KINGSTON FOSSIL PLANT (KIF) - ANNUAL INSPECTION OF WASTE DISPOSAL AREAS

ANNUAL INSPECTION OF WASTE DISPOSAL AREAS

KINGSTON FOSSIL PLANT NPDES PERMIT NO. TN0005452 ANNUAL ASH POND DIKE INSPECTION 1999

PICTURE 2 - NOTE: LACK OF VEGETATIVE COVER ON DREDGE CELL NO.2

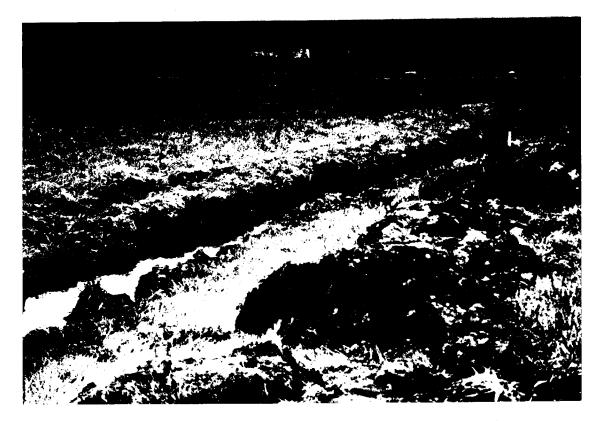
The dike slopes around this area were all stable and most areas had excellent vegetative cover. Most of the Stage B lift has a vegetative cover, however, the top portion of this lift does not have any vegetative cover at all. Lift C1 also does not have a vegetative cover. At completion of Lift C2, plant operations will seed and mulch Lifts C1 and C2 to establish vegetation. Dike slopes with sparse vegetation should continue to be reseeded and mulched until a good vegetative cover is apparent. Plant operations continue to do a commendable job of mowing the slopes. The previously identified minor slough on the west end of dike "C" had not changed in size or appearance. There were some rutted areas noted at the southeastern end of the ditch adjacent to Cell 1. An area of ponded water was noted along the toe of the northwest dike in the ditch between the road and the dredge cells. At the time of inspection, this area was in the process of being regraded to drain through an existing dike drain on dike "C".

- Plant personnel should seed and mulch Stage B lift to provide a good vegetative cover. Dike slopes with sparse vegetation should continue to be reseeded and mulched until a good vegetative cover is present.
